UNITED STATES PATENT AND TRADEMARK OFFICE

APPLICATION NO.	FILING DATE	FIRST NAMED INVENTOR	ATTORNEY DOCKET NO.	CONFIRMATION NO.
10/616,356	07/10/2003	Yasutaka Konno	520.42928X00	2366

Office Action Summary

DETAILED ACTION

Figure 3 – X-ray Detector - AAPA - U.S. Patent Application 10/616,356; pp. 3-4 and 9

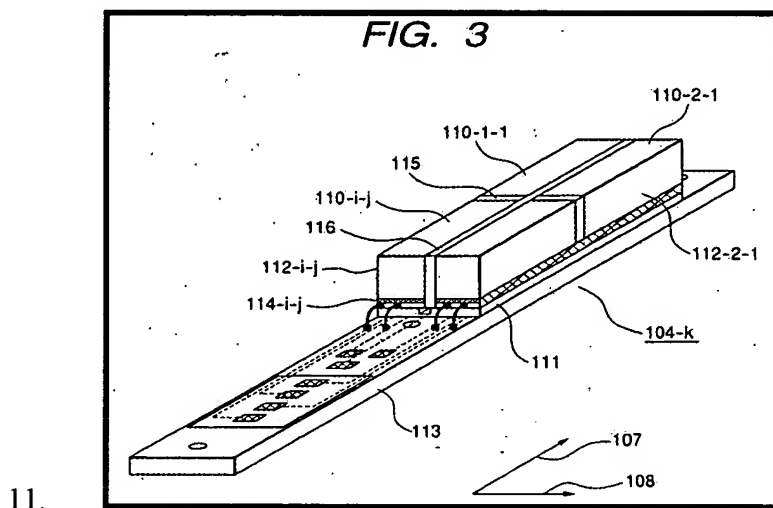
2. Figures 2 and 3 should be designated by a legend such as --Prior Art-- because only that which is old is illustrated (note: Specification p. 9; - see also MPEP § 608.02(g)). Corrected drawings in compliance with 37 CFR 1.121(d) are required in reply to the Office action to avoid abandonment of the application. The replacement sheet(s) should be labeled "Replacement Sheet" in the page header (as per 37 CFR 1.84(c)) so as not to obstruct any portion of the drawing figures. If the examiner does not accept the changes, the applicant will be notified and informed of any required corrective action in the next Office action. The objection to the drawings will not be held in abeyance.

12. As per claims 1 and 4, Applicant's Admitted Prior Art (hereafter AAPA) discloses an X-ray detector (104) comprising: an X-ray sensitive module having a plurality of X-ray detecting

elements (110) having a scintillator (112) converting an X-ray into light via optical reflecting means (115, 116) in a first and second direction; a photo-electric module (111) containing photo-electric means (114) located in a two dimensional manner corresponding to the X-ray detecting elements; a distribution module (113) and module wiring means (not numbered, see Fig. 3 above) electrically connecting electrode pads (not numbered) of the photo-electric modules (111). Examiner notes that the discussion of the Prior art is not explicit in disclosing the presence of detection elements such as a) data lines - commonly understood as column address lines and b) (row) address lines - commonly understood as "scan lines" or simply "address lines" in the detection art. Examiner concludes that it would be understood by one having ordinary skill in the art that the aforementioned Prior Art X-ray detector possessed corresponding address and data lines for reading out electrical signals detected by the X-ray detecting elements (110). Examiner considers "electrode pads" as referring to electrical contact points within the device - which are not numbered, but illustrated in Fig. 3 above. Furthermore, Examiner treats similarly numbered elements (i.e. contrast Fig 1 (110) and Fig. 3 (110)) as functionally equivalent elements (see also Specification p. 39, lines 23-28). AAPA does not explicitly disclose a transparent means optically connected to a light output surface of a scintillator and a corresponding photoelectric means.

Figure 6 & column 9, lines 55-60 – U.S. Patent 6,393,092 to Yoshida

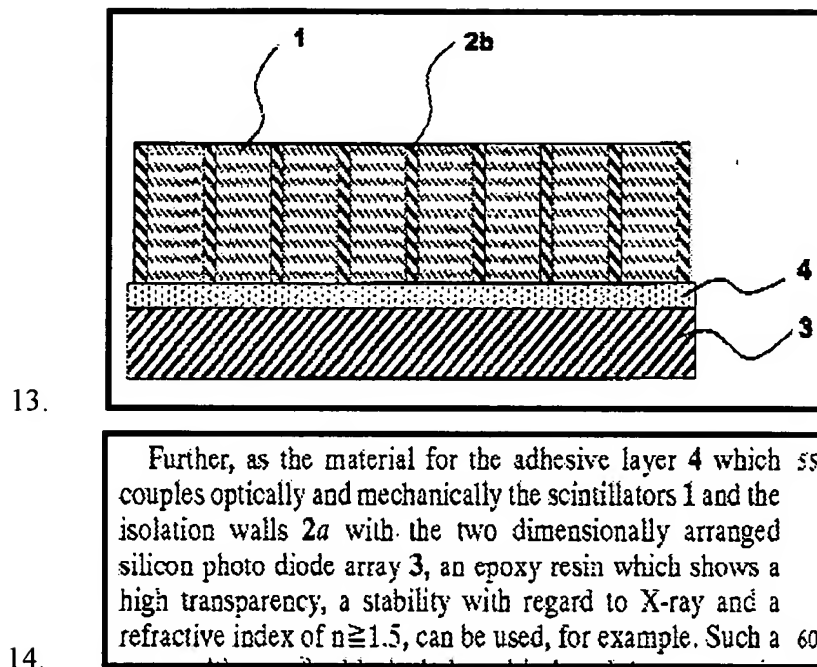
15. Yoshida discloses the utilization of a transparent means (4) for optical coupling of a scintillator output (1) and a corresponding photoelectric means (3). Yoshida teaches that the transparent means serves as an adhesive layer, providing mechanical stability and connectivity between the aforementioned elements, while displaying high transparency and stability in the presence of X-ray radiation. Yoshida suggests the transparency of the transparent means would not adversely affect detector resolution (see above, Fig. 6 and column 9, lines 55-60).

16. It would have been obvious to one having ordinary skill in the art at the time the invention was made to modify the AAPA to incorporate a transparent means optically connected to a light output surface of a scintillator and a corresponding photoelectric means. One would have been motivated to make such a modification for the purpose of providing mechanical adhesion and connectivity between scintillator elements and photoelectric means, while

Figure 2 - X-ray CT Apparatus - AAPA - U.S. Patent Application 10/616,356; pp. 1-3 and 9

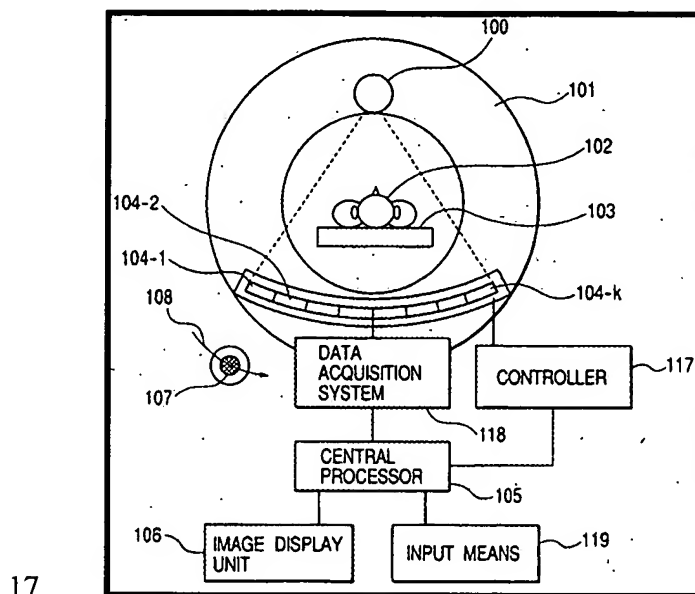
18. As per claims 5-8, AAPA as modified above, discloses an X-ray CT apparatus comprising an X-ray tube (100) a plurality of X-ray detectors (104) a data acquisition system (118), a detector control circuit (117), an arithmetic processing means (105) and an image display (106)- see Fig. 2 above and Specification pp. 1-3; 9; p. 39, lines 23-28.
